PLANNING DEPARTMENT CURRENT PLANNING STAFF ANALYSIS PLATTING BOARD

CASE: S12901
Lot 4, Alpine View Estates Phase 4 Subdivision

REQUEST: Remove plat note #3 from Plat 2024-51 for Lot 4, Alpine View Estates Phase 4 Subdivision

Plat 2024-51
Note 3

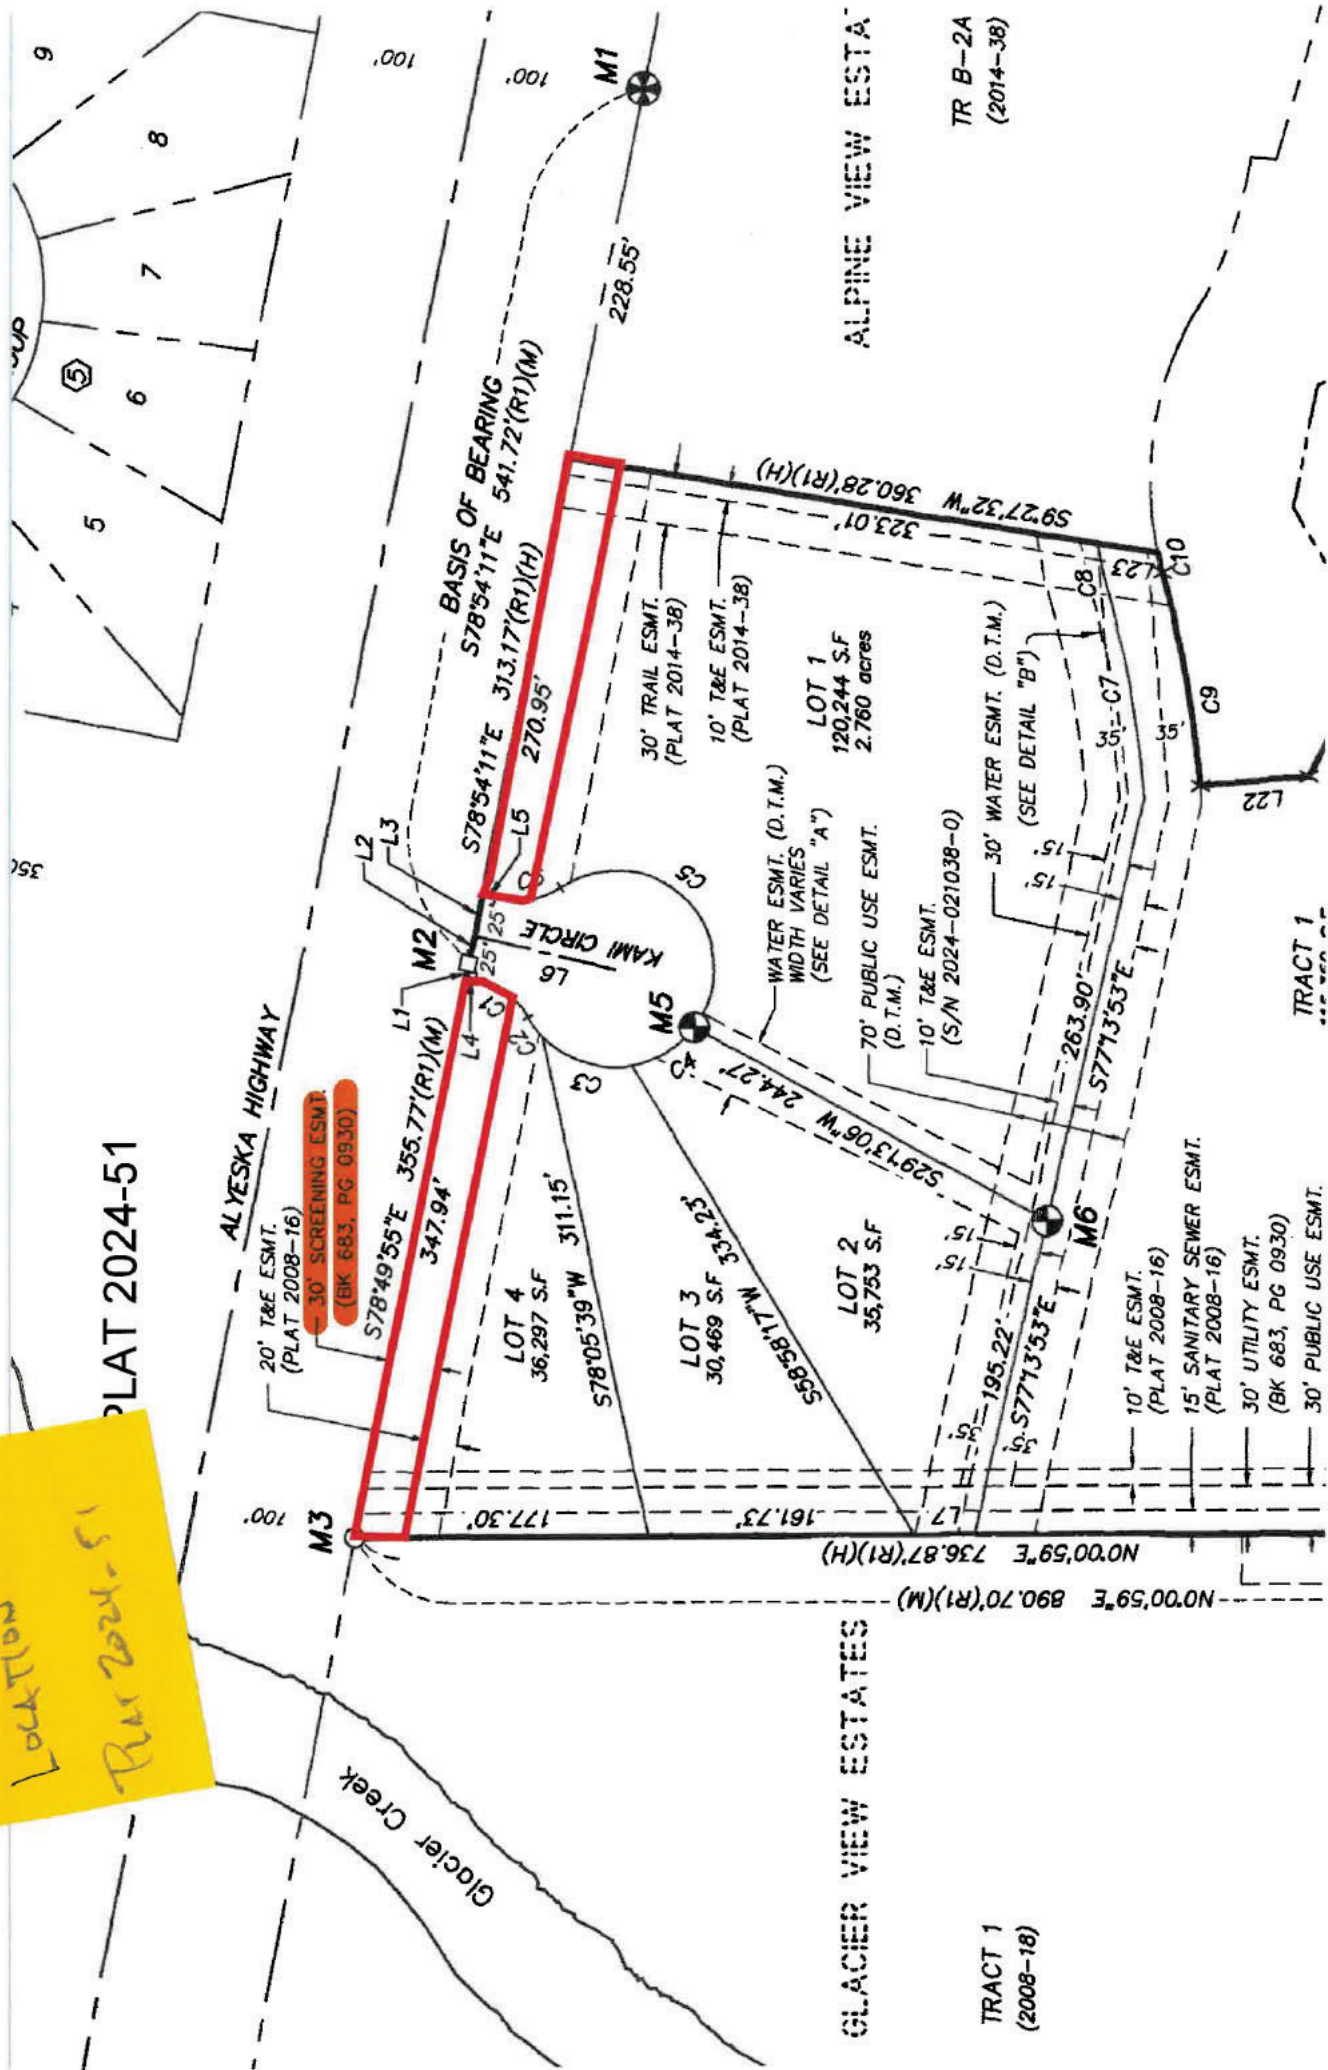
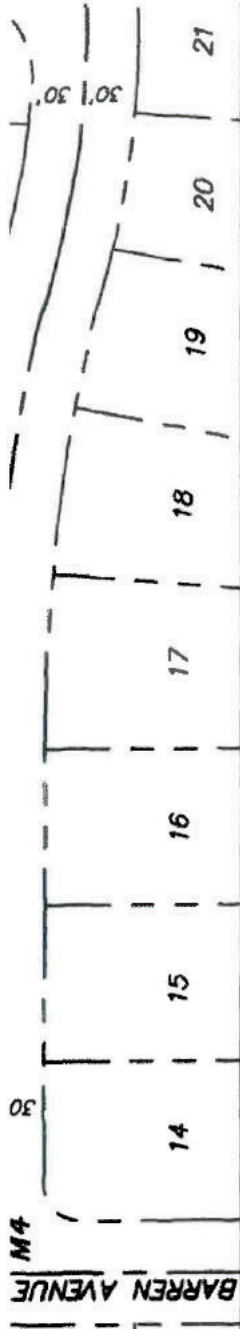
This is a request to remove plat note #3 from Plat 2024-51, Alpine View Estates Subdivision Phase 4, Lot 4. The purpose of the petitioner's request is to allow the owner to construct a residential dwelling on the lot. The Planning Department supports the removal of plat note # 3 as Anchorage Municipal Code (AMC) Title 21 establishes similar protections in AMC 21.09.070.6.b.

The petitioner’s request is to remove the plat note #3 so the property owner can build a multi-family residential development within the gR-4 (multi-family residential) zoning district. This will allow more buildable area on the lot as it is a narrow wedge-shaped lot encumbered by the screening easement and the 20-foot telecommunications and electric (T&E) easement.

Conditions that required the plat note have changed because the regulations established by site development and design standards in AMC 21.09.070, such as setback area vegetation with Alyeska Highway Frontage standards, did not exist or apply to this property when the original plat note was created on the plat. At the time of the original subdivision for Plat 2003-25 and the original screening easement by document in 1981, plat notes afforded protections in the absence of land use regulations. AMC 21.09.070.6b. provides highway screening protections through a 25-foot landscaping buffer. Current code for setback area vegetation standards negates the need for the plat note. Removal of plat note #3 would not reduce protections to properties.

1. The Alaska Department of Transportation and Public Facilities (DOT&PF) states that the applicant should verify property boundaries, and ensure any vegetation removal and/or development does not encroach into DOT&PF right-of-way. DOT&PF will not allow any direct access to Alyeska Highway. All lots must use Kami Circle for access.

- A. Approval of the request to remove plat note #3 from Plat 2024-51 for Lot 4, Alpine View Estates Subdivision, Phase 4, that states:

“The 30’ screening easement along the north boundary of Tract B-2A and B-2B shall retain existing, undisturbed vegetation and is exclusive of any utility easements.”, subject to the following condition:

1. Record a resolution with the State of Alaska Recorder’s Office recognizing removal of the plat note and providing proof to the Planning Department.
